SUBJECT: Approval of Induced Seismicity Mitigation Plan (ISMP) edits associated with Department of Energy (DOE) Award Number DE-EE0002777, *Recovery Act: Newberry Volcano EGS Demonstration*

Appendix J: Proposed Amendments to Induced Seismicity Mitigation Plan

Figure J-1. Worst case modeled stimulation and flowback of well NWG 55-29, 10-fold increase in pore compressibility. Blue = injection period, red = flowback period.

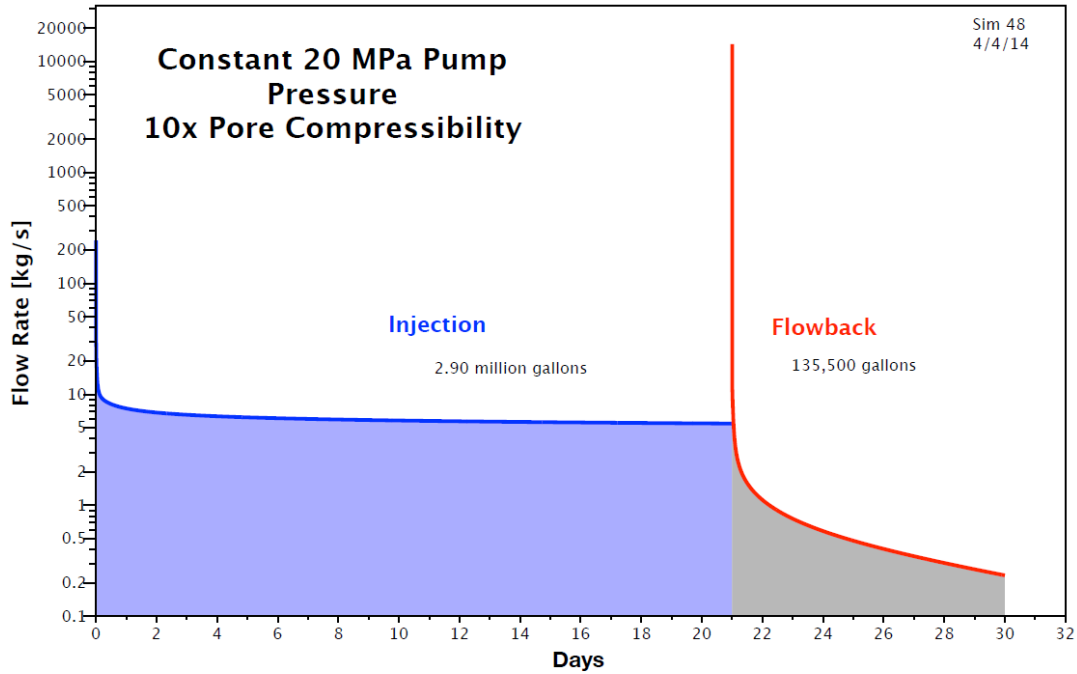
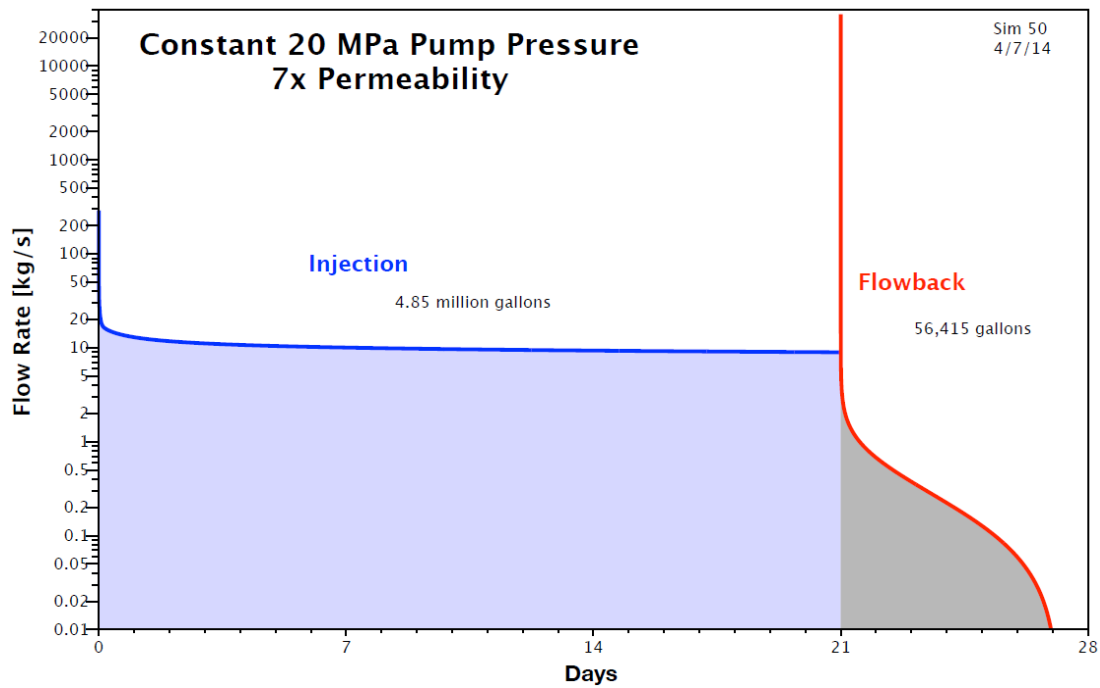
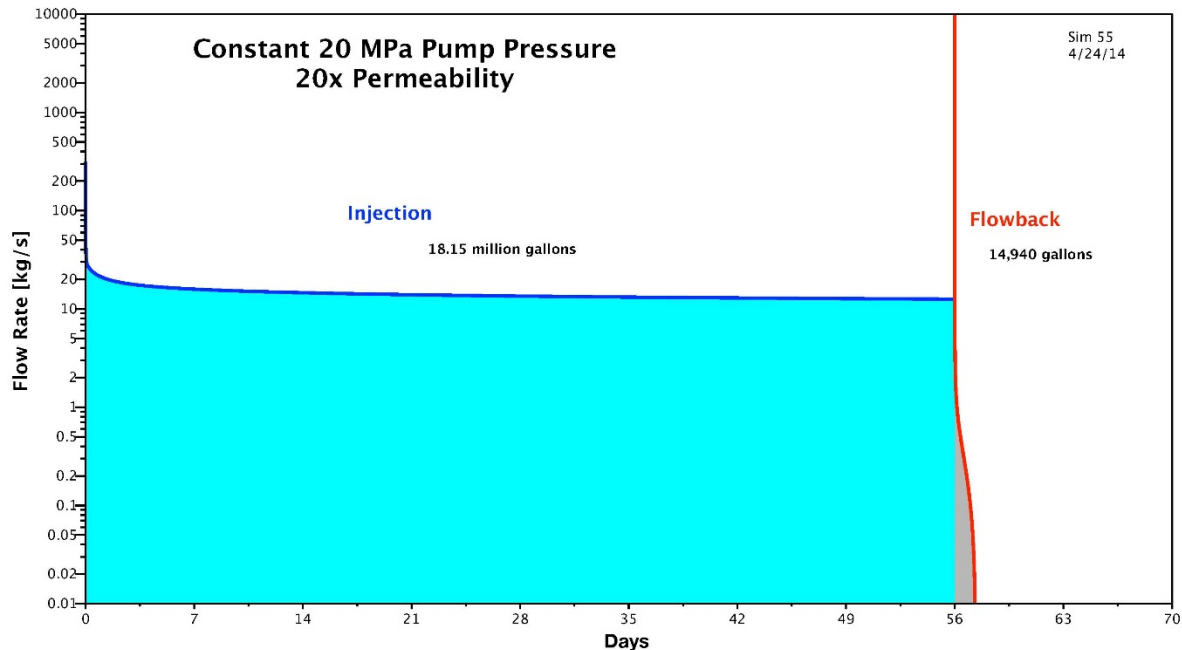
Figures J-1, J-2, and J-3 illustrate the range of modeled stimulation scenario results. In the first, pore compressibility increased ten-fold with no change in reservoir permeability by injecting 2.9×10^6 gallons of water at 96 gpm over 21 days. The well then flowed back 135,000 gallons, or 4.7%, over nine days. Such an increase in compressibility without a corresponding increase in permeability is not a realistic scenario and thus considered a worst case. In the second scenario, permeability was increased seven-fold ($k_x=3.5e^{-17} \text{ m}^2$, $k_y=k_z=7.e^{-17} \text{ m}^2$) by injecting 4.85×10^6 gallons of water at a rate of 170 gpm over 21 days. The well then flowed back only about 56,000 gallons, or 1% of the total injection volume, over six days. In the third case, the simulation continued much longer, for 56 days in order to reach a volume nearer the injection goal of 20 million gallons. In this case, the cooling of the rock mass caused even less flow back than the 21 day scenarios. Therefore, the modeling results indicate that a revised a well pad flowback storage capacity of 5% will be sufficient, and that constructing a pipeline for restimulating well NWG 55-29 in 2014 is neither necessary nor cost effective.

Figure J-4. Comparison of Injected Volume to Maximum Moment for various injection projects (McGarr, 2014) with Newberry EGS seismicity data overlain. This figure is also shown and discussed as Figure 5-22 in main text.

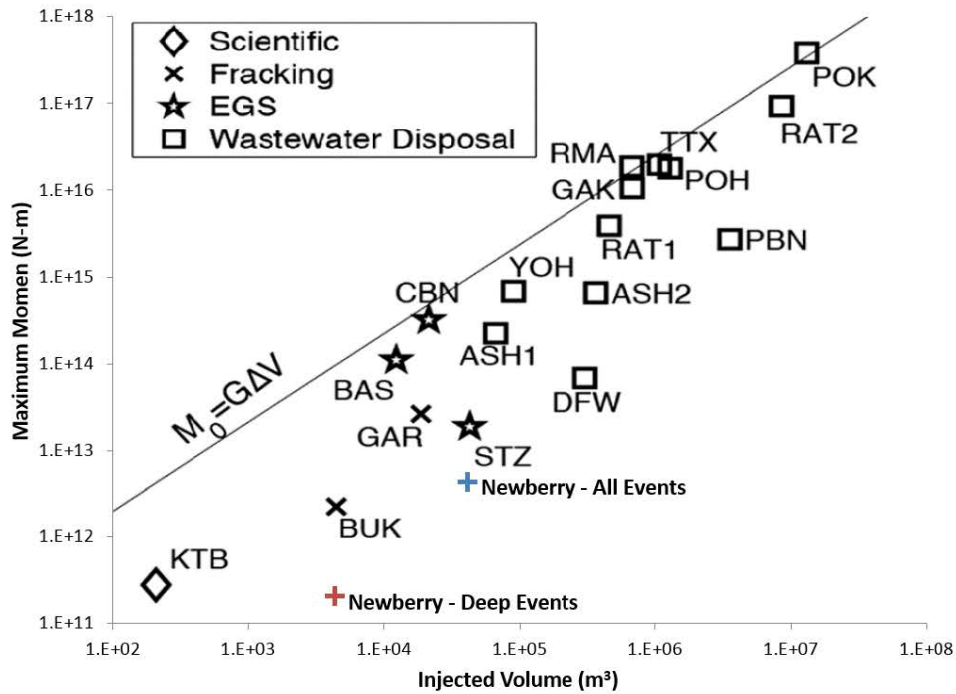
Since the original ISMP was written, additional tracking parameters has been developed to monitor for changes in seismic risk. For example, McGarr (2014), showed the relationship between seismic moment of the largest induced event (or cumulative seismic moment) and cumulative injected volume (Figure J-

4). The $M_0 = G\Delta V$ line in Figure J-4 is an upper bound to the relationship between injected volume and seismic response. This analysis shows that, compared to other injection projects, the seismicity induced during the Newberry EGS demonstration in 2012 is far from the $M_0 = G\Delta V$ boundary, indicating a low seismicogenic potential. This graph provides an empirical and theoretical basis for judging the potential for induced seismic events which might be felt. Therefore, a version of this graph, updated with the cumulative volume and both cumulative and maximum moment will be included in the regular seismicity reports.
